APPLICATION NO.	FILING DATE	FIRST NAMED INVENTOR	ATTORNEY DOCKET NO.	CONFIRMATION NO.
09/989,845	11/21/2001	James E. Lerch JR.	011215	1251

Office Action Summary

Claims 1-3, 8-10 and 18-20 are rejected under 35 U.S.C. 102(b) as being anticipated by Case, 3,388,892 (see reproduced marked-up attachment).

3,388,892 (Case)

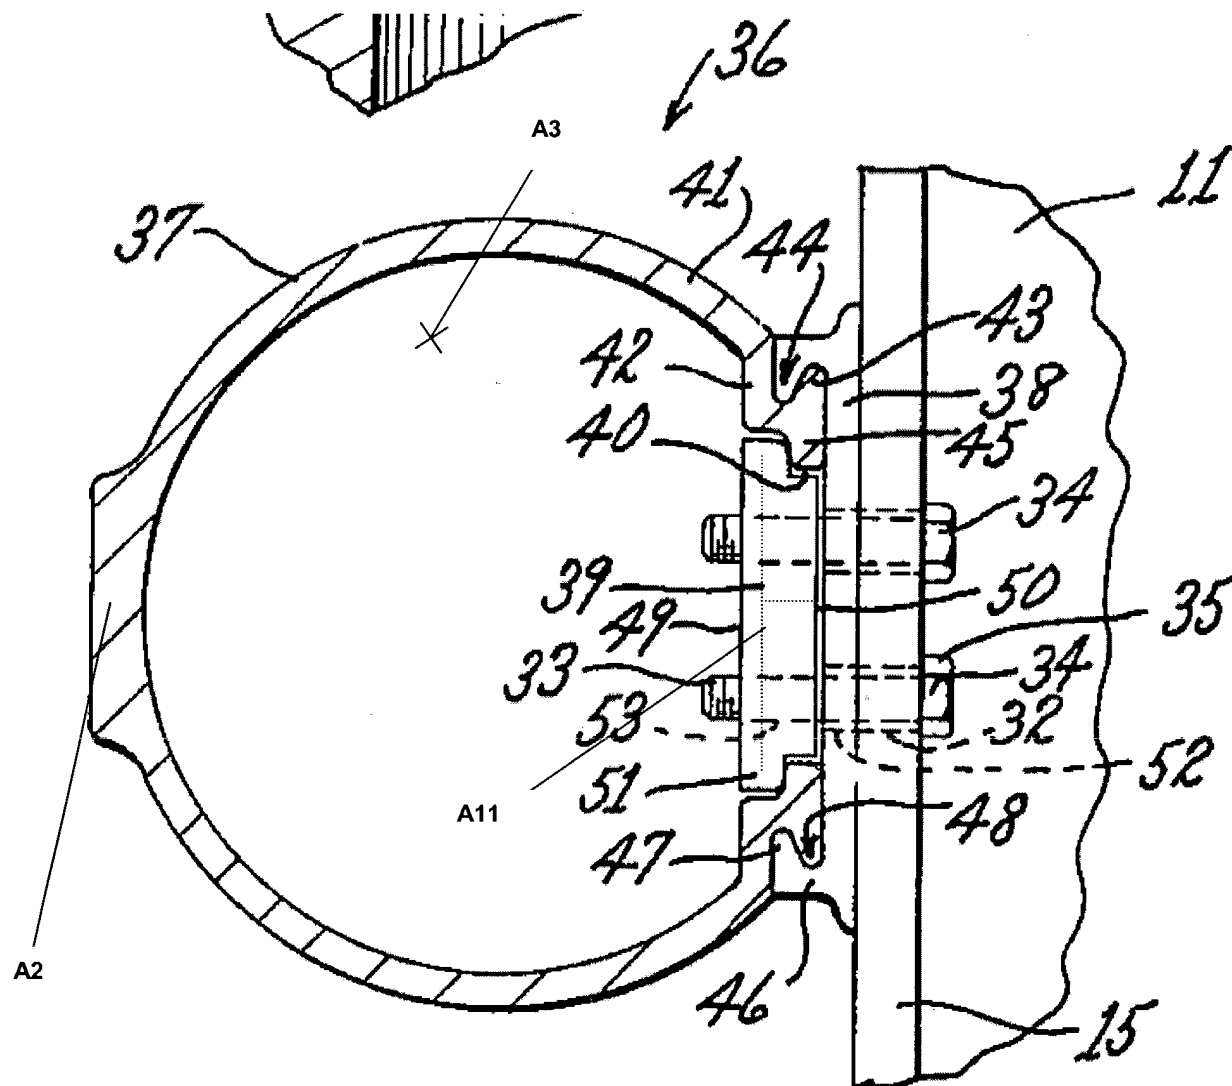
Regarding claim 1, Case discloses an improvement, in a barrier, comprising at least one longitudinally extending railing **82**, vertically extending posts **56**, and fastening means **42c**.

The railing **82** has at least one generally T-shaped channel **86**. The channel **86** extends in a longitudinal direction **A3** of the railing **82** and at least one leg **A12** of the channel **86** extends inwardly within the channel **86**.

The posts **56** each have an elongated body **A5** and at least two flange segments **58**. The flange segments **58** extend outwardly in opposite directions **A7** and have at least one perforation **71** in each of the flange segments **58**.

The fastening means **42c** are slidably embraced within the channel **86** and the fastening means **42c** extend through the perforation **71** in the flange segments **58** and fastened to the posts **56** to provide a variably select elevation of the longitudinally extending railing.

Regarding claims 2, 9 and 19, the T-shaped channel **86** has an inwardly extending tab **A12** at an end of a leg **A13** of the channel **86**.

Regarding claim 18, Case discloses in Figures 1-3 an apparatus comprising a barrier **32**. The barrier **32** has at least one longitudinally extending railing **82**, vertically extending posts **56**, and fastening means **42c**.

Regarding claims 3, 10 and 20, the railing **82** has another T-shaped channel **90** thereby the railing **82** has at least two T-shaped channels **86,90**.
